## **GOULSBY SUBDIVISION**

APPLICATION NUMBER 6 DATE October 15, 2015

REQUEST Subdivision

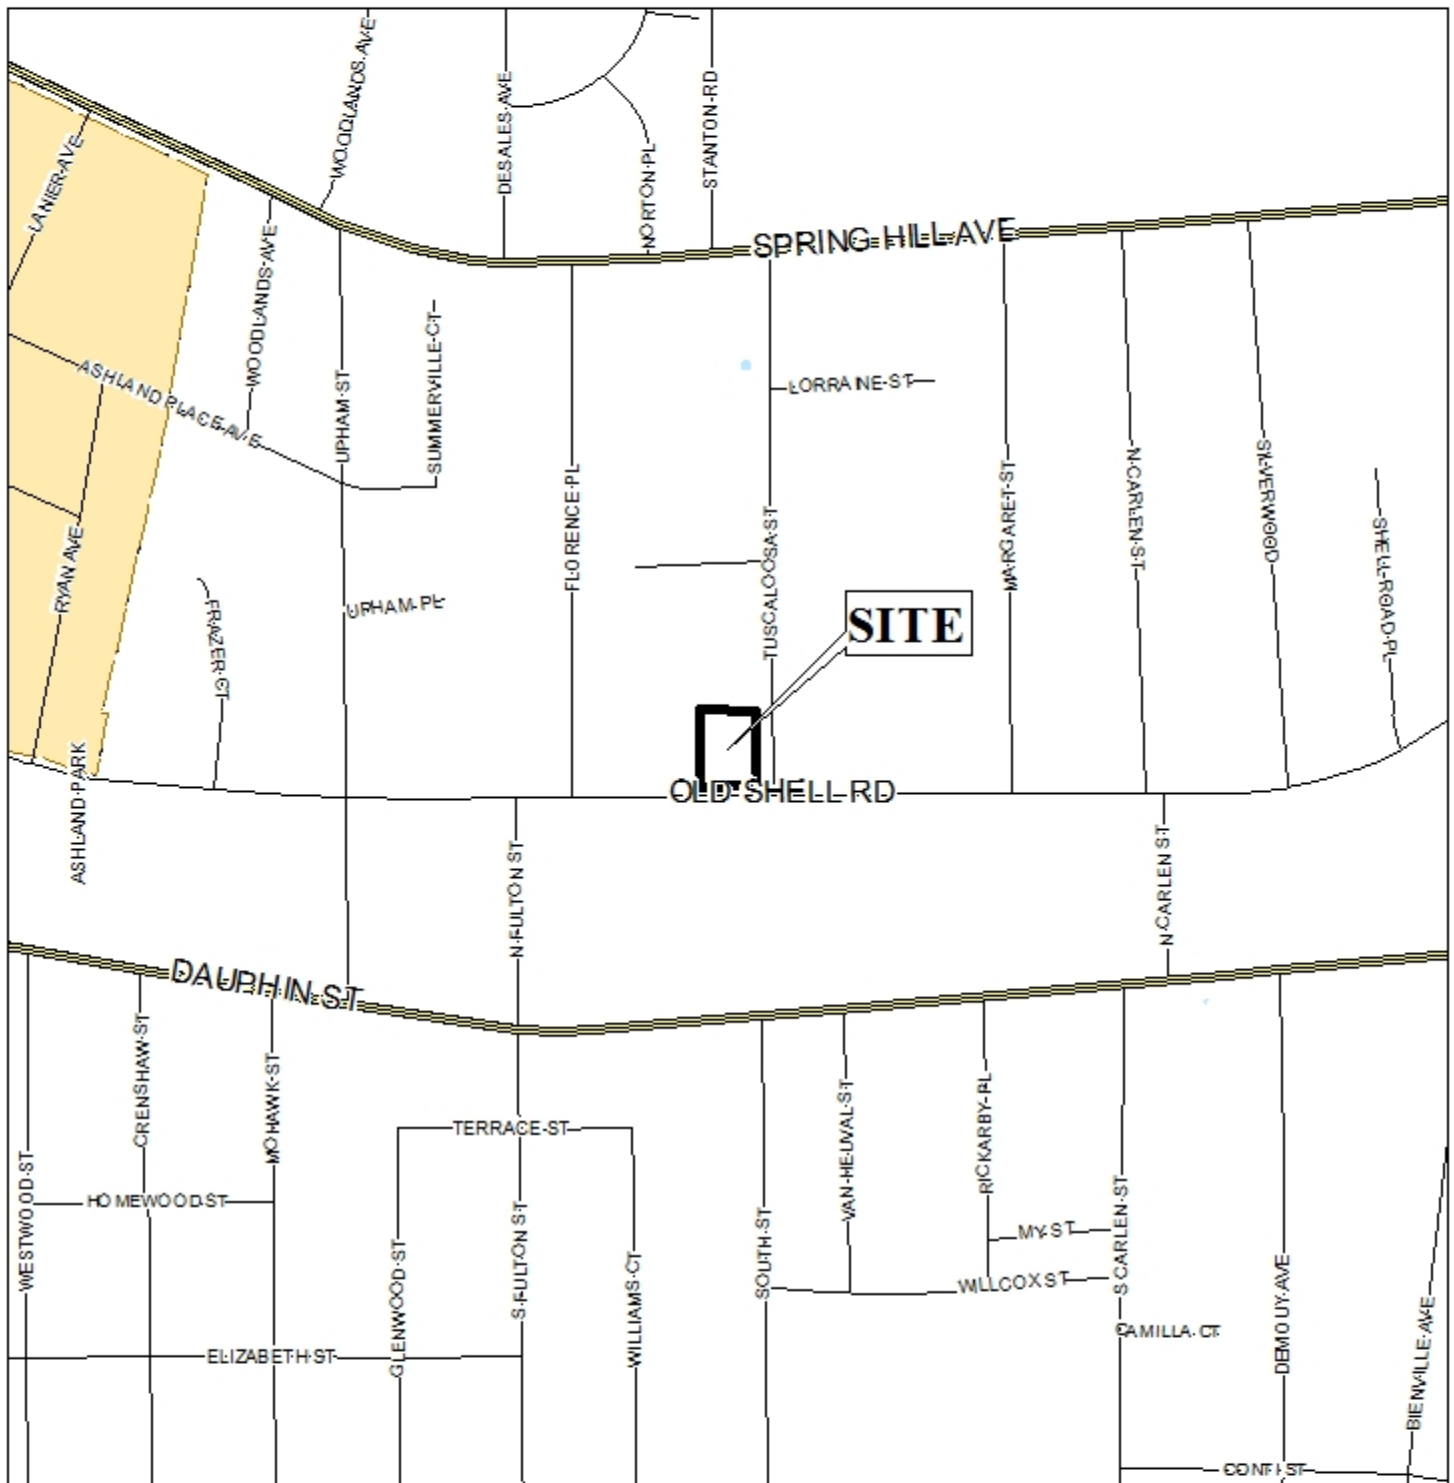
The proposed lots, as depicted, meet the minimum area requirements as regulated by the Subdivision Regulations; however, the proposed lots are substandard in width and, as a result, exceed the maximum width-to-depth ratio. It should be noted that there are several substandard lots in the vicinity which were developed well before the current regulations went into effect, therefore a waiver of Sections V.D.2. and V.D.3. of the Subdivision Regulations regarding lot width and maximum depth may be appropriate; however, reorienting the proposed lots 2, 3, and 4 to face Tuscaloosa Street would be out of character for the area. Nevertheless, if approved, the plat should be revised to label the sizes of each lot in both square feet and acres, or a table should be furnished on the Final Plat providing the same information.

It should be noted that the existing metes-and-bounds parcel contains a single-family, residential dwelling that would be divided between the interior lot line of proposed Lots 3 and 4. If the proposed subdivision results in the house straddling the interior lot line between proposed Lots 3

and 4 and does not meet front, side, *and* rear setback requirements, the structure should be moved to comply with these requirements or be removed from the site prior to the signing of the Final Plat. Any site improvements to proposed Lots 3 and 4 regarding the existing single-family, residential dwelling are subject to the appropriate building permits and should comply with all applicable codes and ordinances.

- 1) Revision of the plat to illustrate the reconfiguration of proposed Lots 2, 3, and 4 toward Old Shell Road.

# DETAIL SITE PLAN

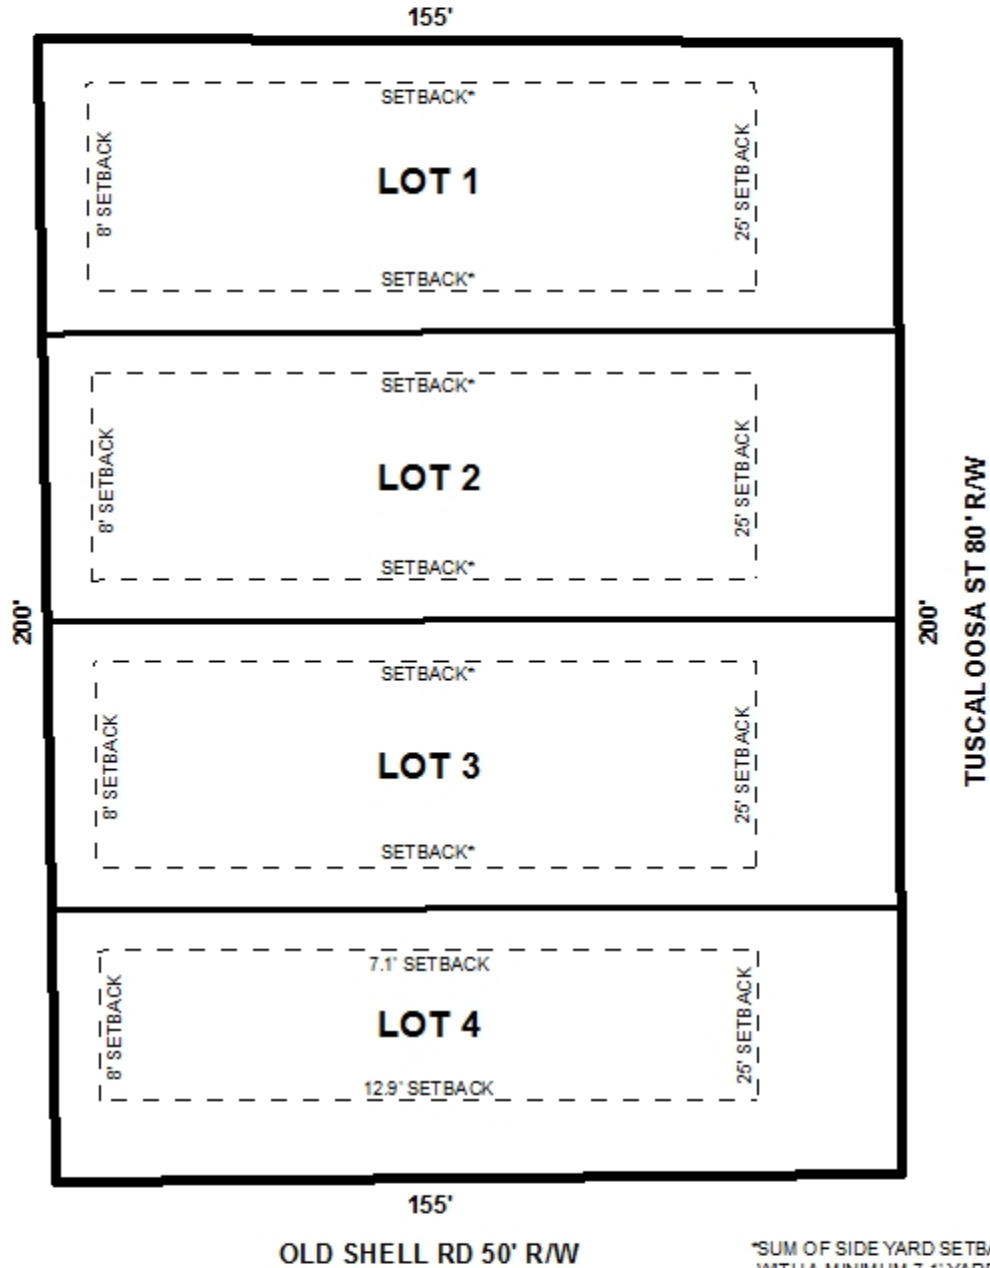
As a means of access management, a note should be required on the Final Plat stating that Lot 1 is limited to its existing curb cut to Tuscaloosa Street, that Lots 2, 3, and 4 are limited to one curb cut each to Tuscaloosa Street, with their sizes, locations and designs to be approved by Traffic Engineering and conform to AASHTO standards.

The preliminary plat indicates a minimum 25' building setback line along Tuscaloosa Street for each of the proposed lots as required by Section V.D.9. of the Subdivision Regulations. It should be noted that a 12.9' setback is illustrated for proposed Lot 4 along Old Shell Road, which meets the requirements for a corner lot 50' wide per Section 64-4.D.7. of the Zoning Ordinance. If approved, this information should be retained on the Final Plat.
